Project
PROPOSED DEVELOPMENT, THE MEADOWS, STRANGFORD ROAD, DOWNPATRICK

Title
PRELIMINARY SURFACE WATER ATTENUATION SYSTEM USING OVERSIZED PIPES & HYDROBRAKE

Your reference:
Our reference: IN1-18-12387

RE: PROPOSED DISCHARGE OF STORM WATER AND RE-ALIGNMENT OF WATERCOURSE AT THE MEADOWS, DOWNPATRICK.

Drawing No. C106 | Revision

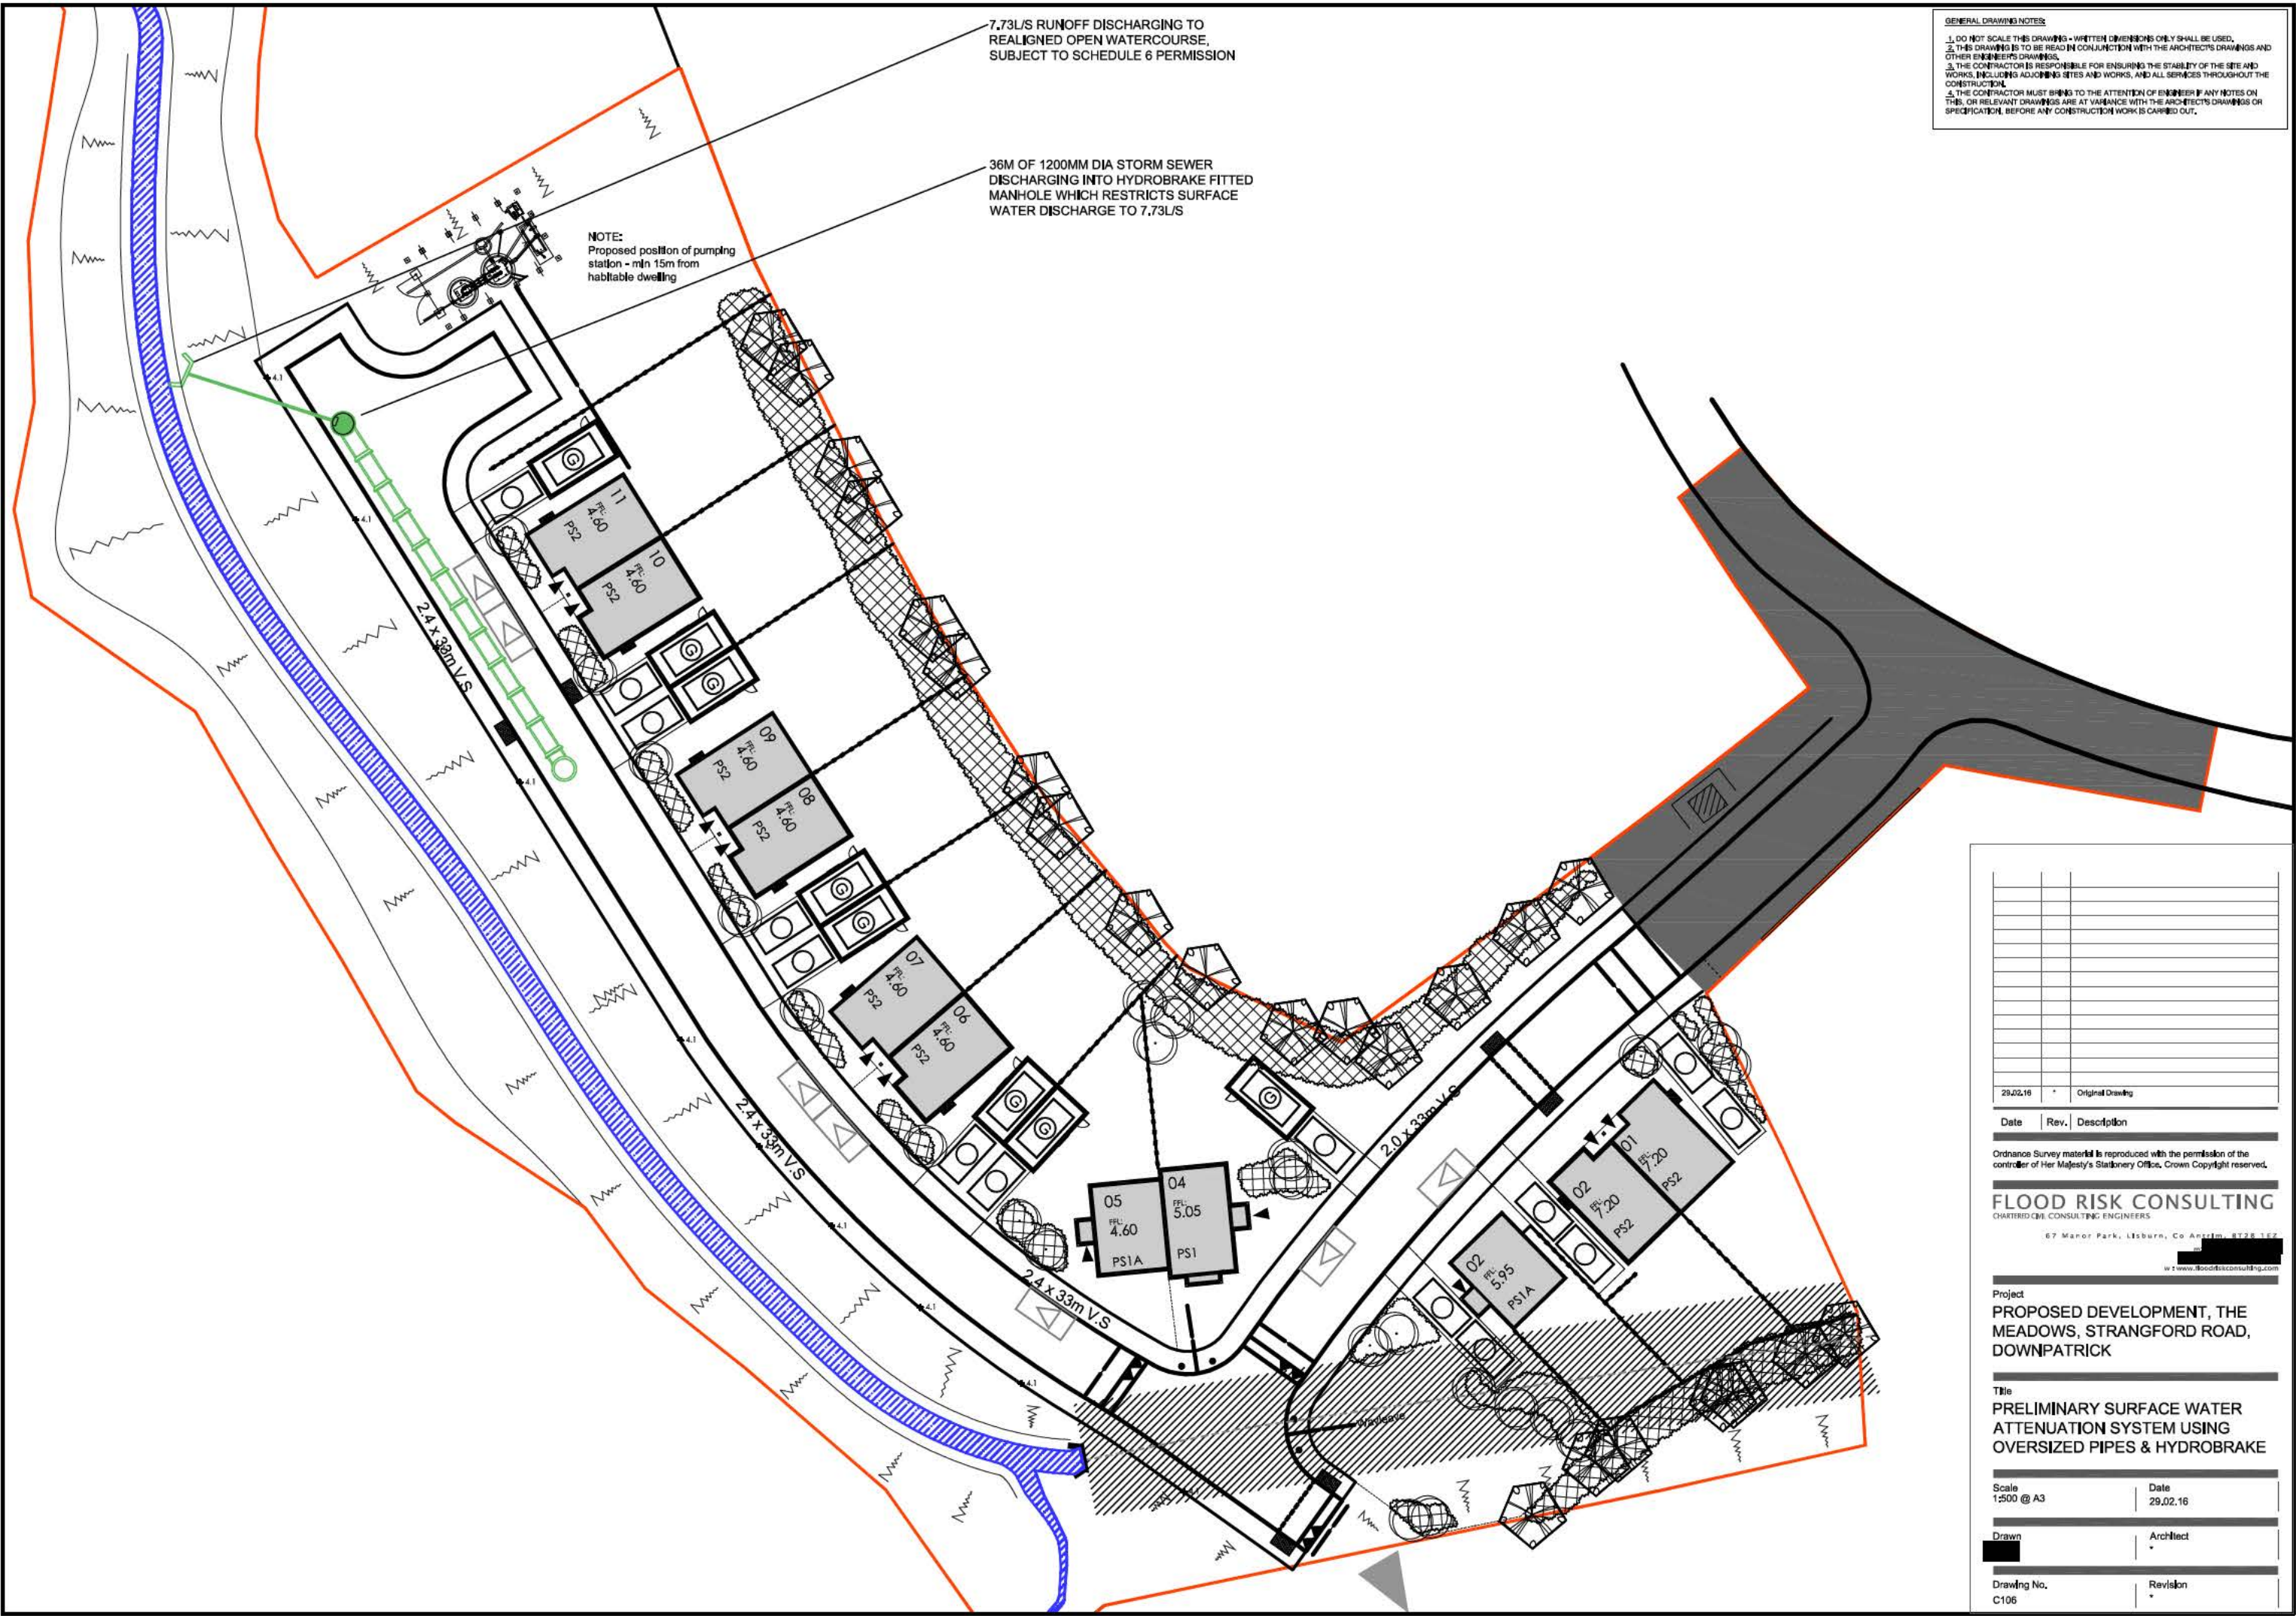
The Department for Infrastructure Rivers consents to your proposal to discharge 7.73 l/s to the undesignated watercourse as per your Flood Risk Assessment & Drainage Assessment and Drawing Number's C106 and C401.

The overflow pipe should be turned in the direction of flow and anti-scour measures taken to prevent bank and bed erosion.

If your client deems it necessary to fit a Flap valve the continuing maintenance of this valve will be their responsibility.
